# HILLSIDE AT LORSON RANCH FILING NO. 1

FINAL PLAT  
 HILLSIDE AT LORSON RANCH  
 FILING NO. 1  
 JOB NO. 43-141  
 DATE PREPARED: 09/20/2022  
 DATE REVISED: 03/15/2023

PCD FILE NUMBER SF-23-001

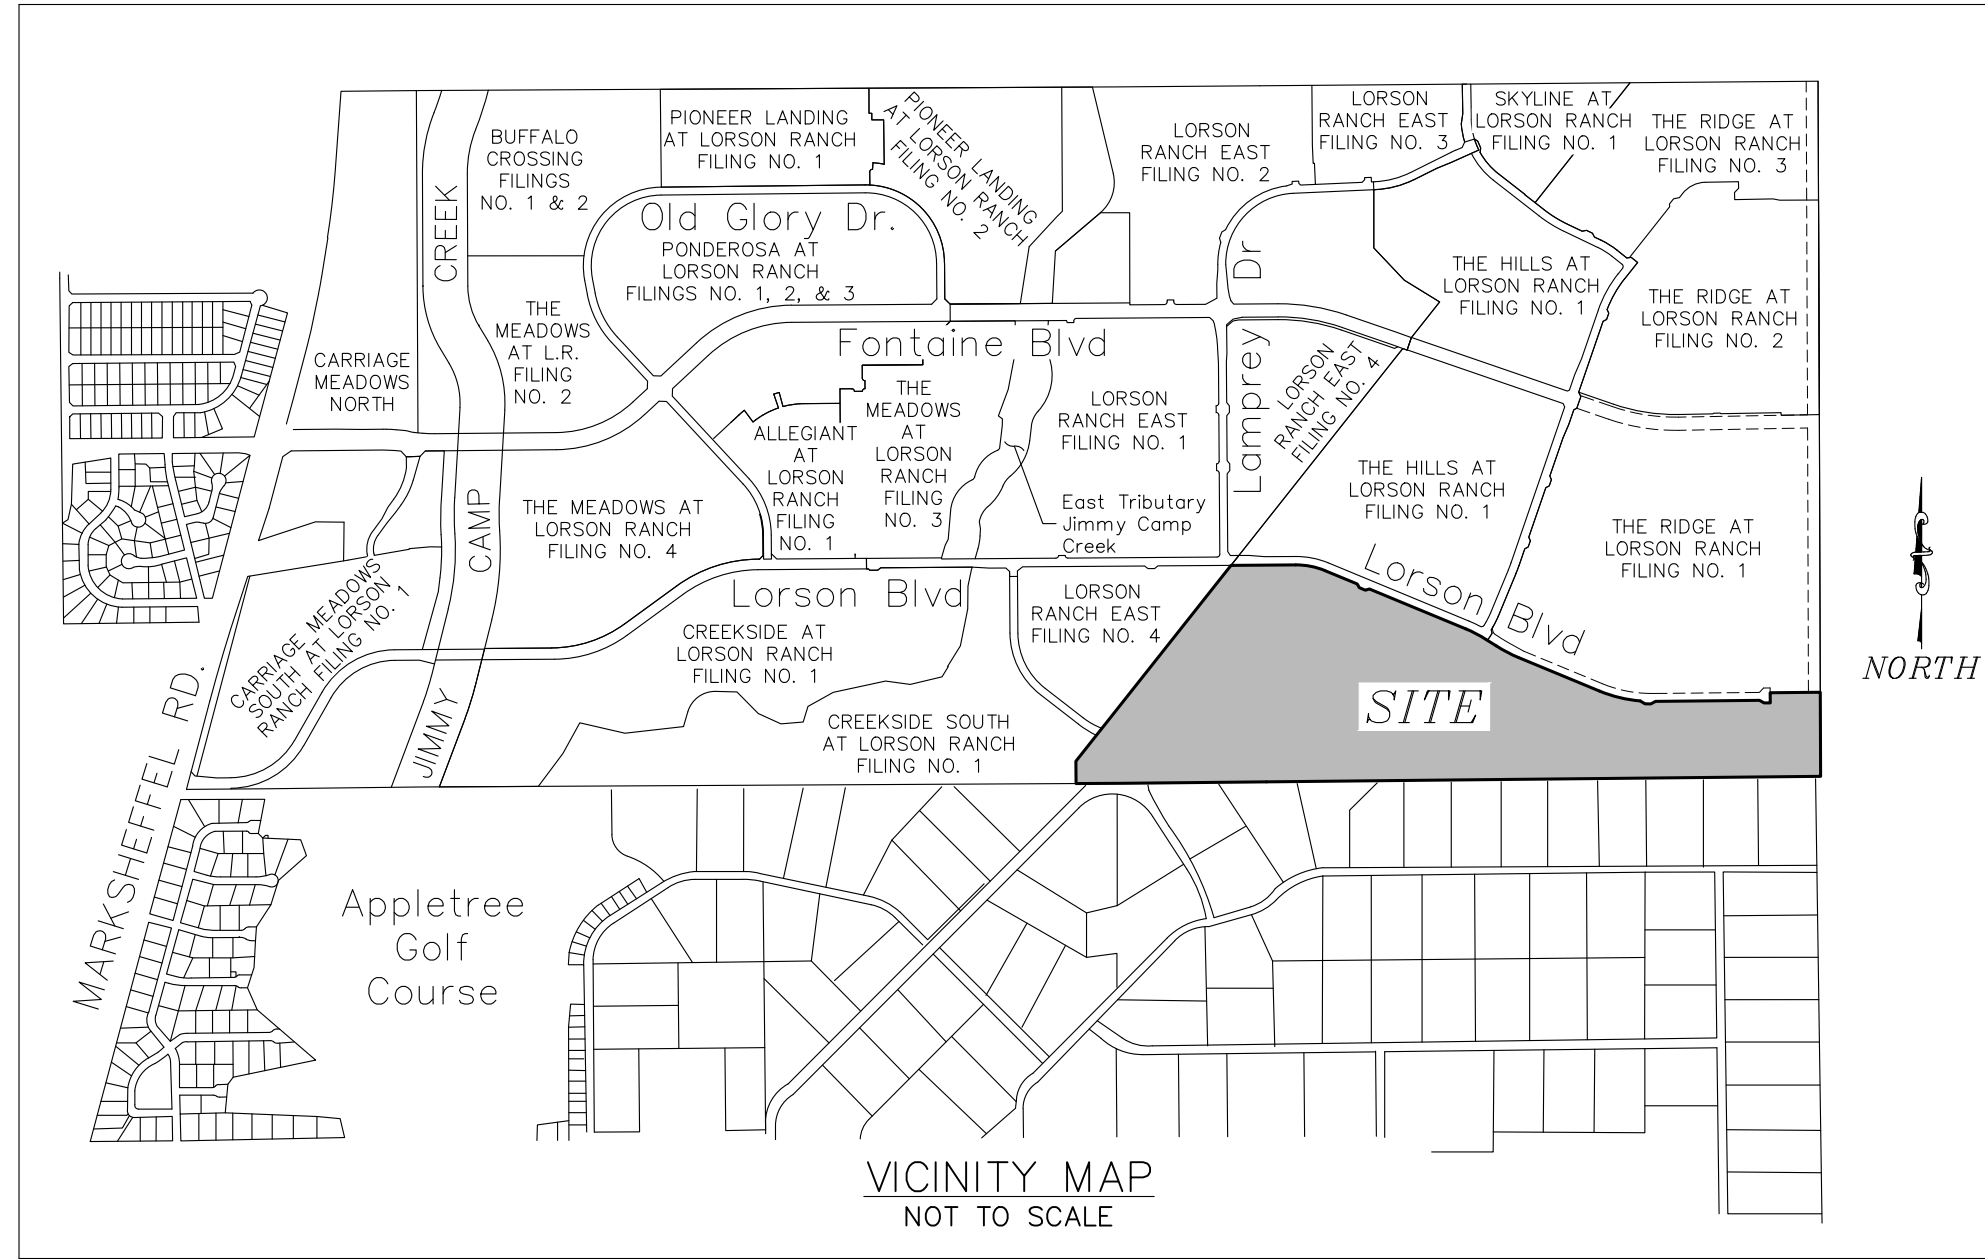
please provide recorded Parkland Agreement

please provide recorded Parkland Agreement

SHEET 5 OF 11

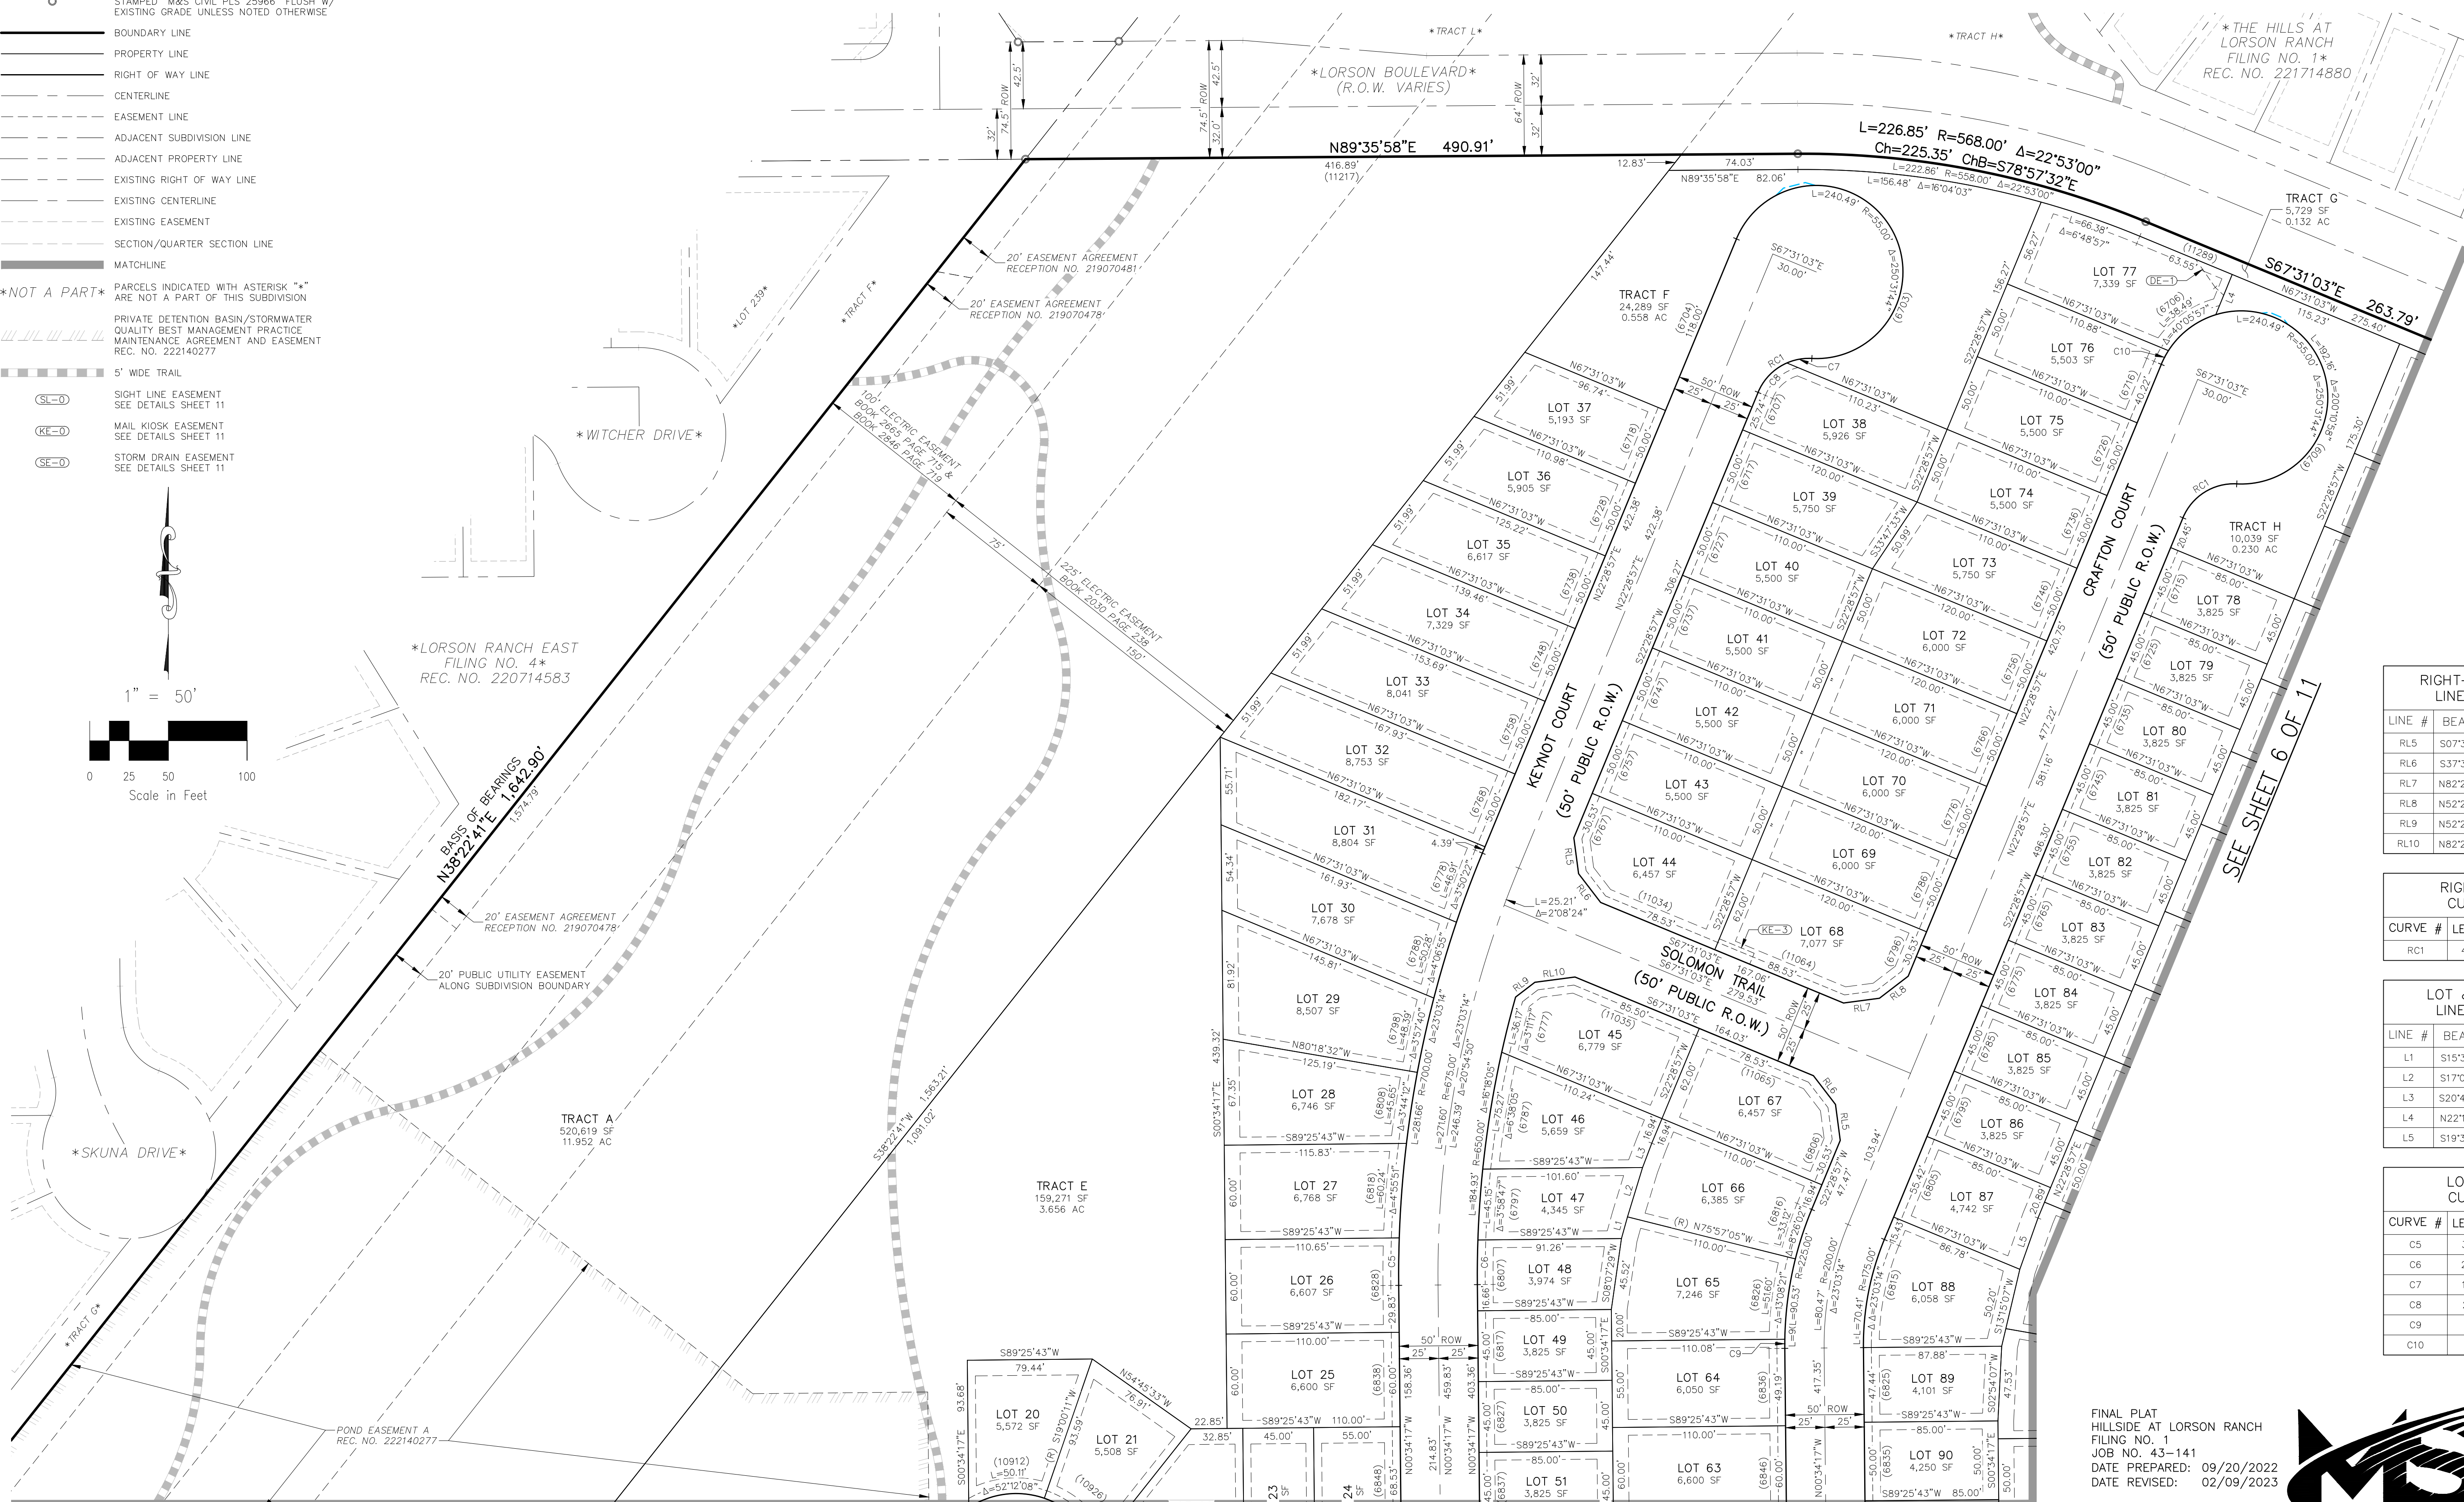
Provide / label public improvements easement
